ADVISORY  
 BULLETIN

No. 99-16

## Official Notification Federal Boat Safety Act – Commander 3000 Classic Remote Control Decal

### Incorrect Starboard Mount Decal

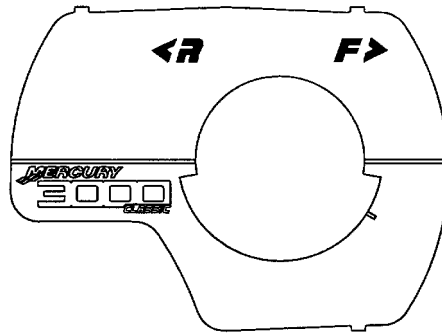
A quantity of Commander 3000 Classic Panel Mount Remote Controls with box date code listed were shipped with an incorrect bezel decal. The incorrect decal has the "R" (indicating reverse) printed to the front and the "F" (indicating forward) printed to the rear of the bezel when the control is starboard mounted. For starboard remote control mounting, a new Mercury p/n 37-827289--4 bezel must be installed.

Replace the incorrect bezel. Removal and disassembly of the remote control is required. Refer to the remote control service manual 90-814705R2 Section 11.

Qty 1 p/n 37-827289--4 Mercury decal.

### INSPECTION/TEST

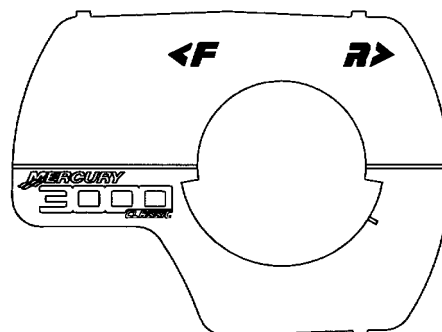
Inspect for an incorrect decal that has the "R" printed to the front and the "F" printed to the rear of the bezel when the remote control is starboard mounted.

### Incorrect Bezel Decal

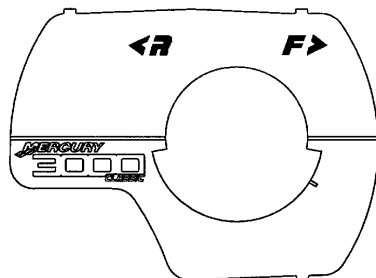
You are affected by this recall, if the bezel decal has the “R” printed forward of the control handle.

3. **If the control bezel decal is incorrect:** Make an appointment with a dealer authorized to service your Mercury, Mariner, or MerCruiser product and deliver your boat **and this letter** at the appointed time.
4. **If the control bezel decal is correct or the boat is sold or traded:** Please complete the lower portion of the form printed on the reverse side of the letter and return the letter to us in the envelope provided.
